Newcastle Inner City Bypass
Rankin Park to Jesmond

**Newcastle Inner City Bypass –
Rankin Park to Jesmond
Submissions and preferred
infrastructure report**

June 2018

Figure 5-11a
 Drainage infrastructure

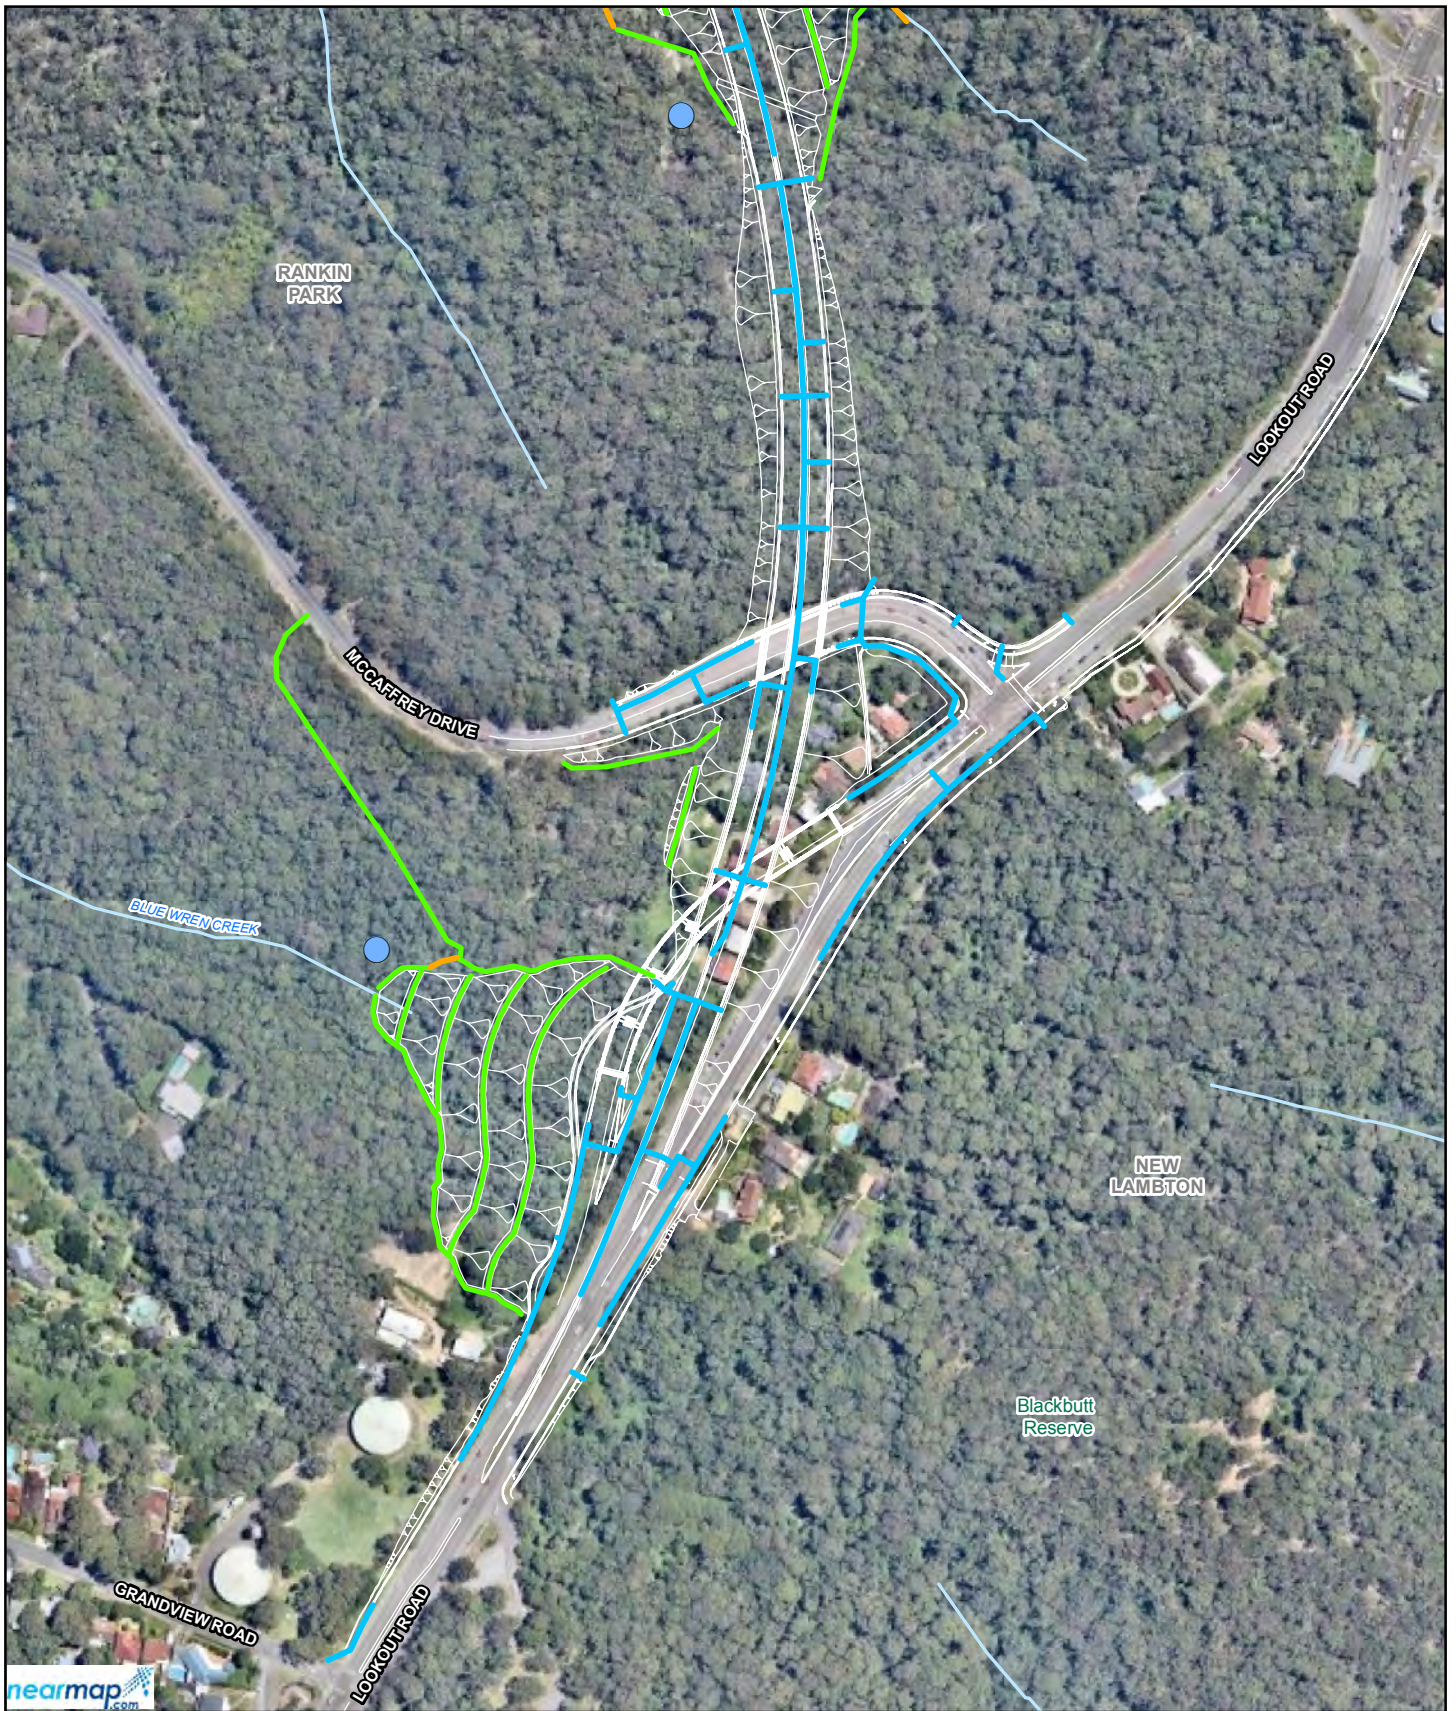
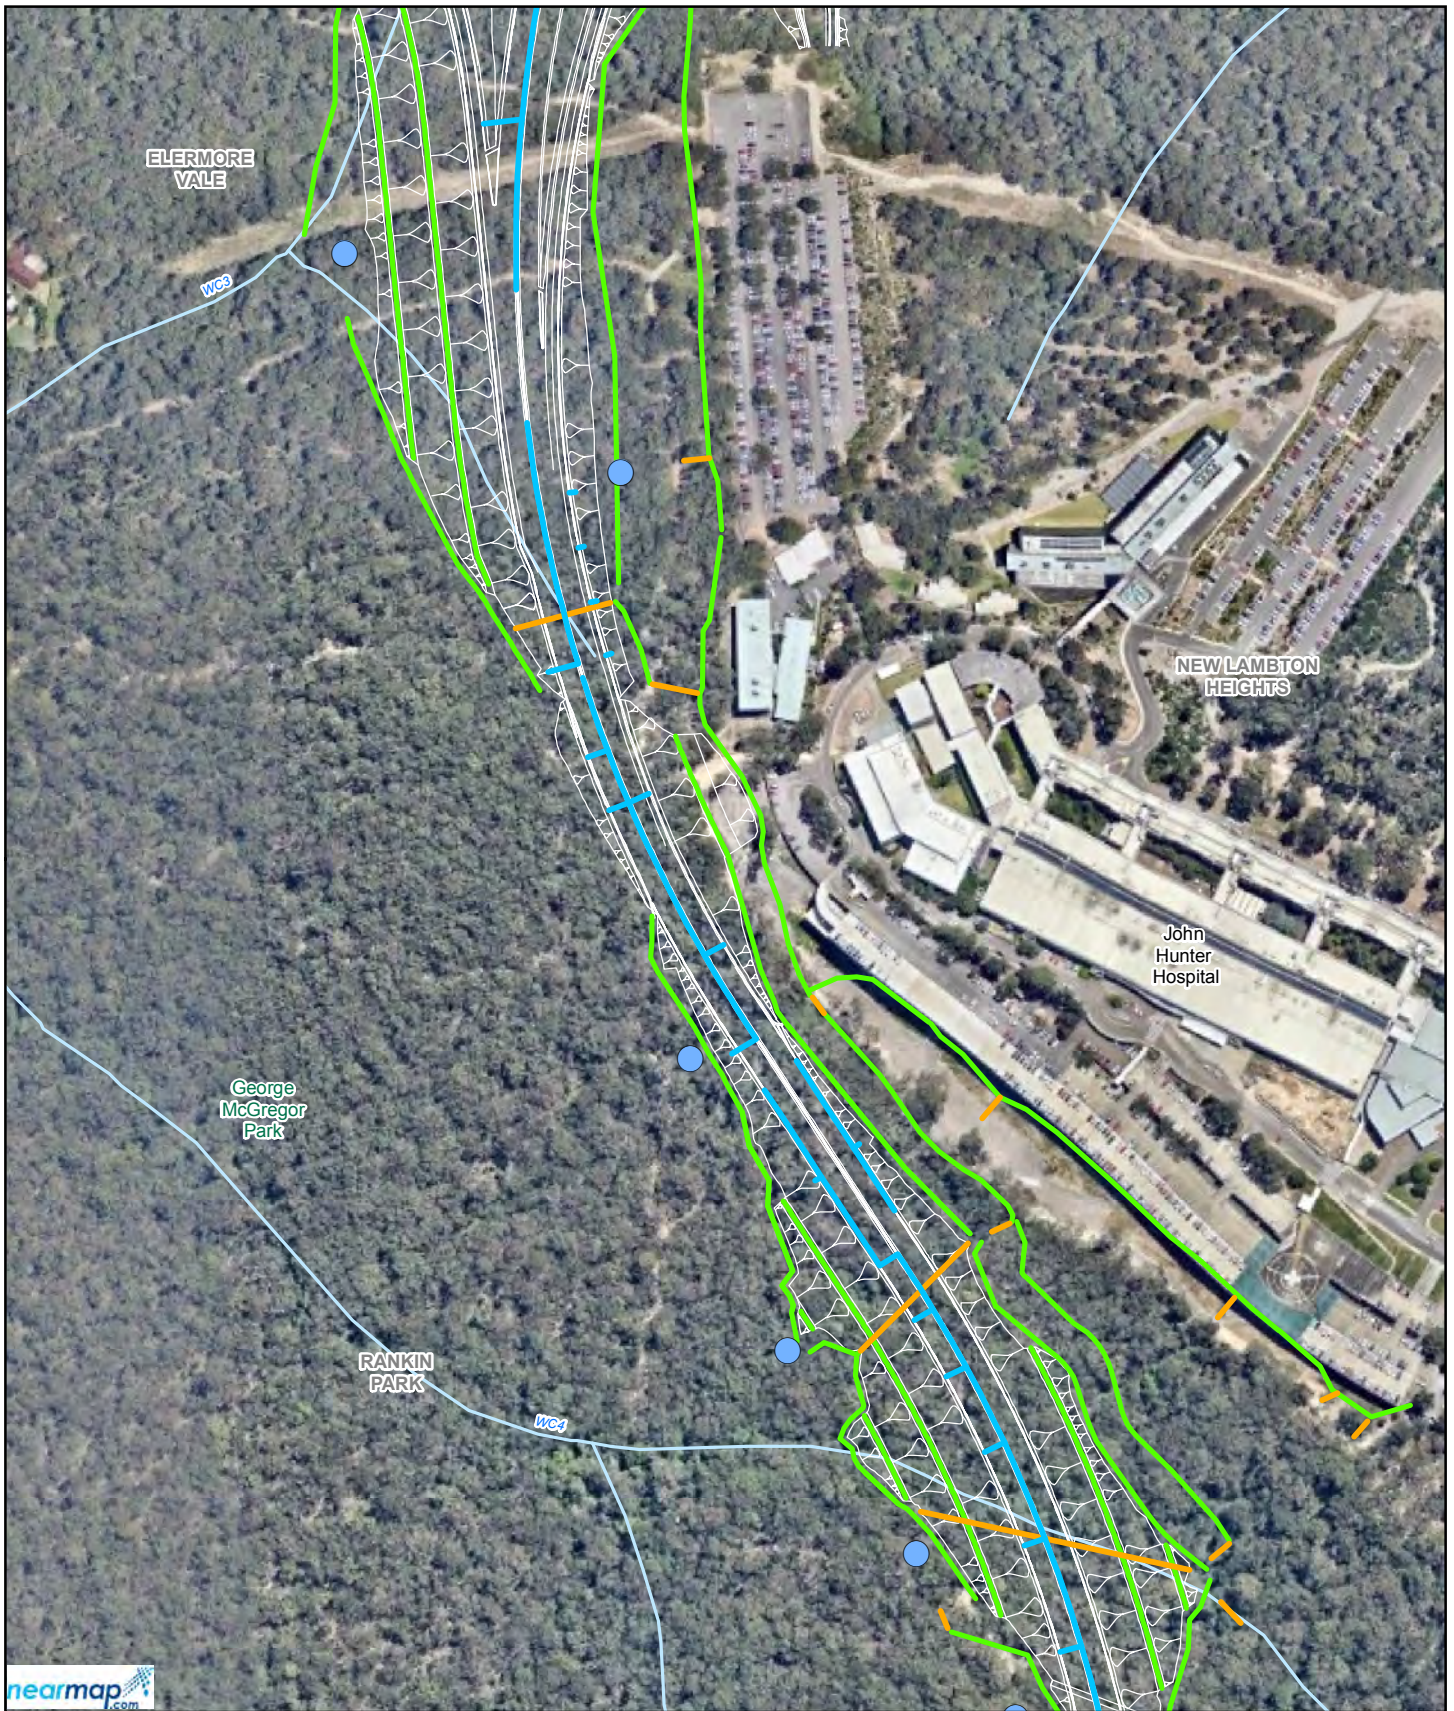
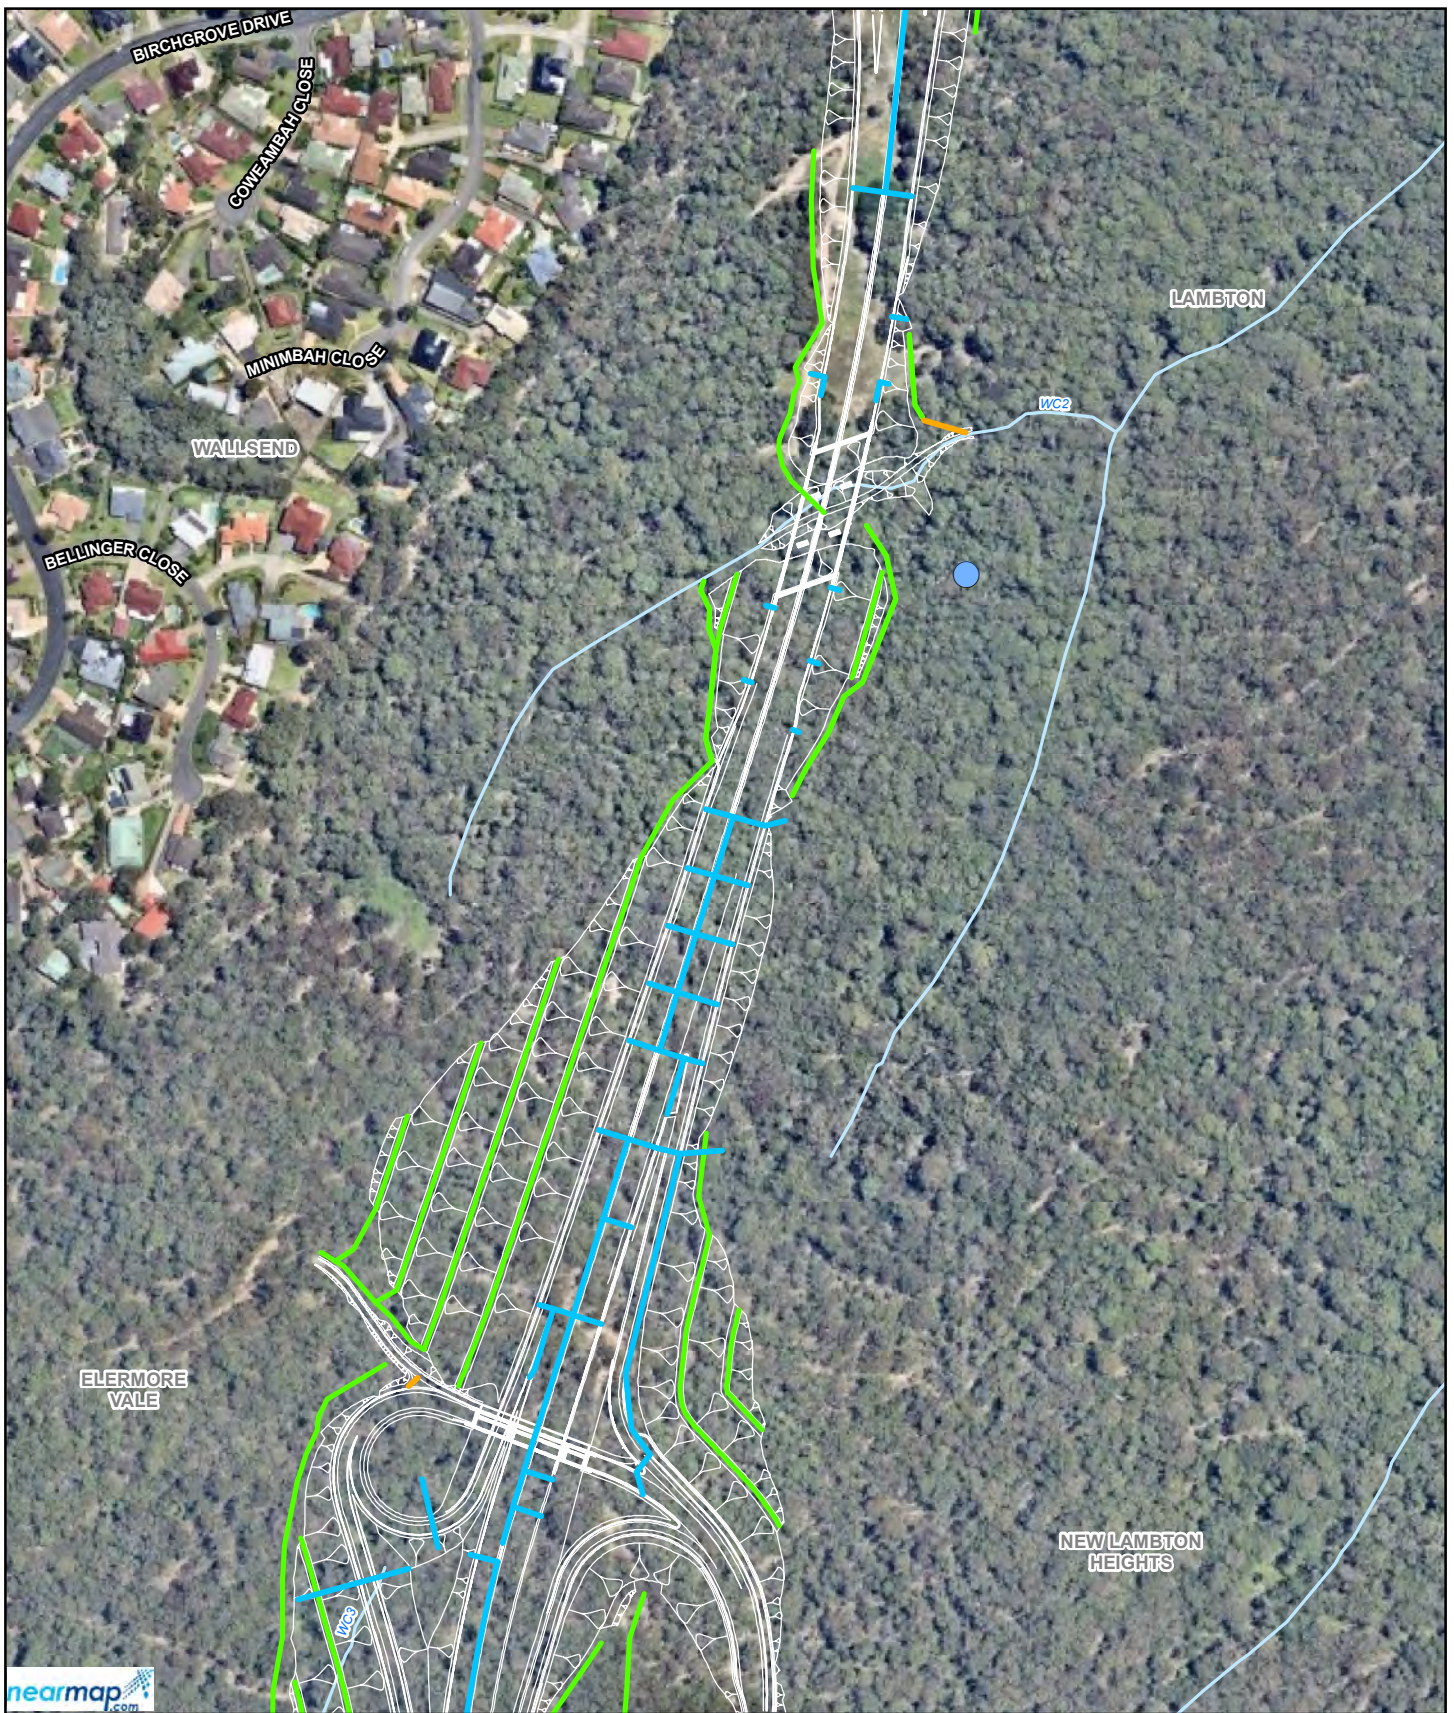
Due to the design refinements discussed in this report the proposed drainage infrastructure has now been refined as shown in Figure 5-11. The refined design is consistent with that described in the EIS and includes minor changes to cross drains, pavement drains and longitudinal catch drains to reflect other design refinements including the:

Due to the design refinements discussed in this report the proposed flood mitigation work has now been refined as shown in Figure 5-11 and consists of:
